*Nomad*

SERVICE BULLETIN

SUBJECT: STATIC VENT WEATHER PROOFING (MODIFICATION N289)

NMD-53-4

Weather Strip (P/N 1/N-10-1147)
Figure 1

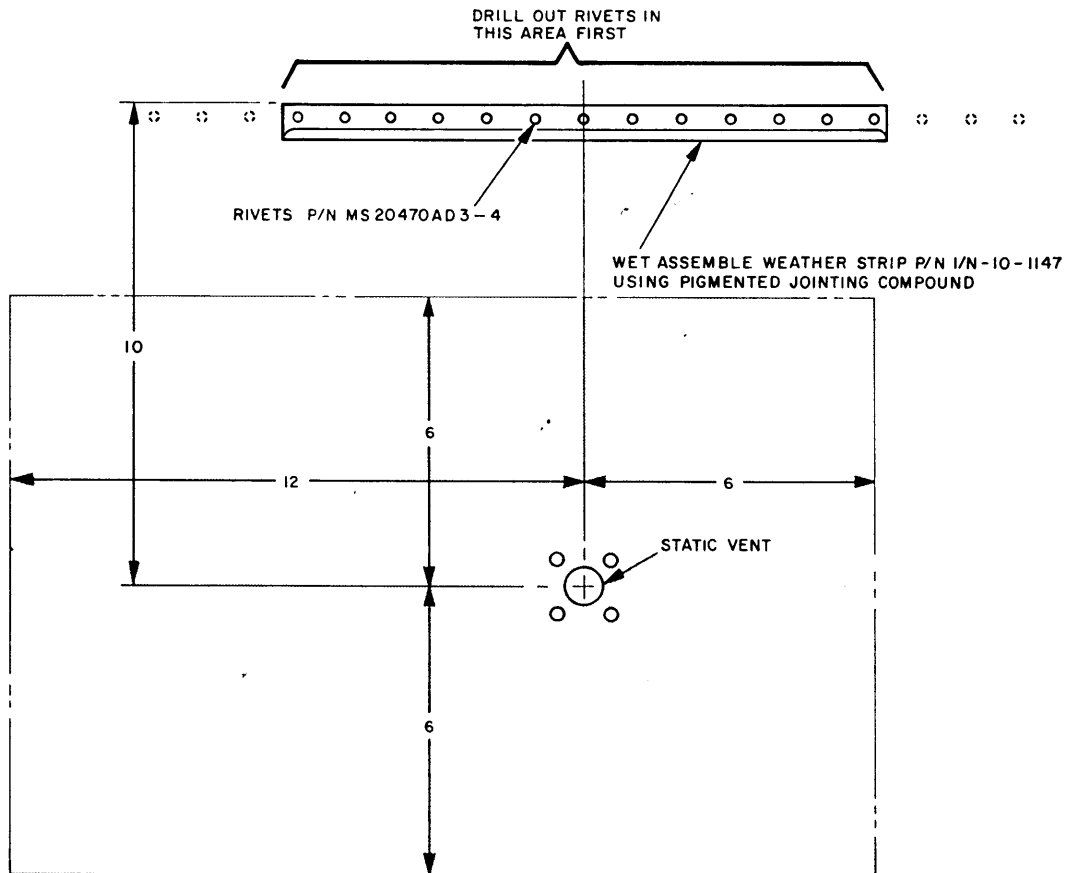
A weather strip is positioned, on each side of the front fuselage, above the static vents.

Alternatively operators may manufacture the parts to the information supplied in this Service Bulletin (Ref Figure 1).

- A. Locally manufacture two weather strips P/N 1/N-10-1147 (if required) to the specifications and dimensions shown in Figure 1.
- B. Remove the interior trim on both sides of the flight compartment as required (Ref MM 25-10-00).
- C. Drill out the rivets on both sides of the fuselage in the area indicated on Figure 1.
- D. Position each weather strip as shown in Figure 2. Back drill and deburr the 2.45 mm diameter holes in the weather strips.
- E. Wet assemble a weather strip P/N 1/N-10-1147 on each side of the front fuselage skin and rivet using rivets P/N MS20470AD3-4. Oversize rivets (Ref Para 3.A) may be used if existing rivet holes were damaged when removing original rivets.
- F. Replace interior trim (Ref MM 25-10-00).
- G. Paint weatherstrips to existing paint scheme as required.

- NOTES— (1) ALL DIMENSIONS IN INCHES
- (2) PRIME THE WEATHER STRIPS USING SUITABLE CHROMATE ETCHING PRIMER
